# STAFF REPORT Major Subdivision

## Docket No. ES-204-19-PF Summary No.

**Subdivision:** Shemberdy Park/ Ludger Fortier Plantation **Council District:** 2

Subdivision of Lot 3A, Shemberdy Park, Lot EQ and Parcels AA\*, BB\*, DD\*, Ludger Fortier Plantation into Lots BB-W, D-BB-1, EQ-2, and TU-3A, the dedication of Parcel HC1 to Jefferson Parish

**FIGURE 5**

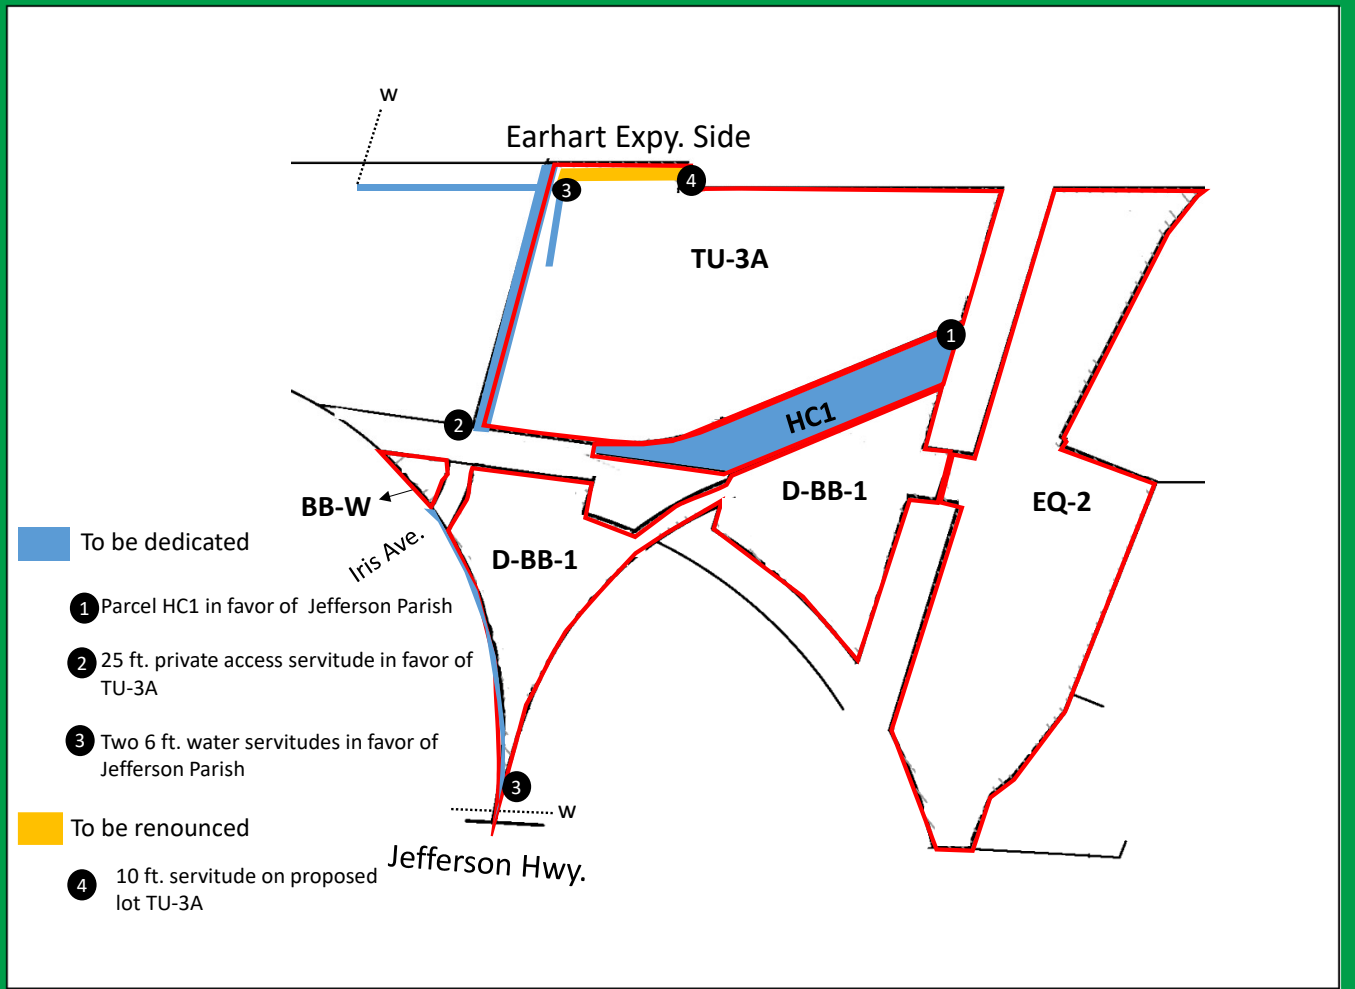
8. Proposed lots D-BB-1 and BB-W have frontage and vehicular access on Iris Ave. Proposed lot EQ-2 has frontage on Jefferson Hwy. Though it does not have direct access from a public right-of-way, proposed lot TU-3A has frontage along a 25-foot wide private access servitude located adjacent west and will be dedicated in favor of Lot TU-3A as part of the subdivision request. Parcel HC1 is proposed to be dedicated to Jefferson Parish and therefore, exempt from frontage requirements of the Code (Figure 5).

9. To facilitate water access, two 6 ft. water servitudes are proposed to be dedicated as part of the subdivision request. All other development related matters will be addressed at the building permit stage (Figure 5).

<p>application would be made to the La State Dept. of Health and Hospitals for installation. Regarding what was added to the survey, if water servitudes are to be dedicated to the Parish a minimum 20' with the line centered will be required; not 6". Also the existing line that is shown crossing the RR tracks ties into the 12" water line along Earhart which is the location per GIS is not maintained by the Parish and would need a servitude dedicated to the Parish. The GIS shows this line extended further south with a hydrant at the end, but the survey shows an existing hydrant further east. In addition, it is not known if the above water line (8") is operational. If the line is not operational then it is the responsibility of the owner to replace the line per Parish standards and obtain permits from DOTD and the railroad if applicable. A small segment of the Creosote Ditch that ties into the Hoey's Canal encroaches into proposed Lot D-BB-1 in the small strip section of the lot that shows the drain line. A servitude will be required. I will defer all comments regarding the Hoeys Canal to the Drainage Dept. No structures allowed inside Parish servitudes. If the lots are to be developed, Drainage Ordinance 19914 shall be enforced during the building permit stage. Drainage requires the retention all existing drainage servitudes within proposed, resub-divided area. Traffic Engineering Division finds that the sight triangles are not an issue at this time and a TIA is not required. Parkways has no comment, no landscape plan submitted.</p>

10. The applicant is aware of the LURTC comments from the Public Works Department, and will submit a revised plat addressing specific servitude issues.
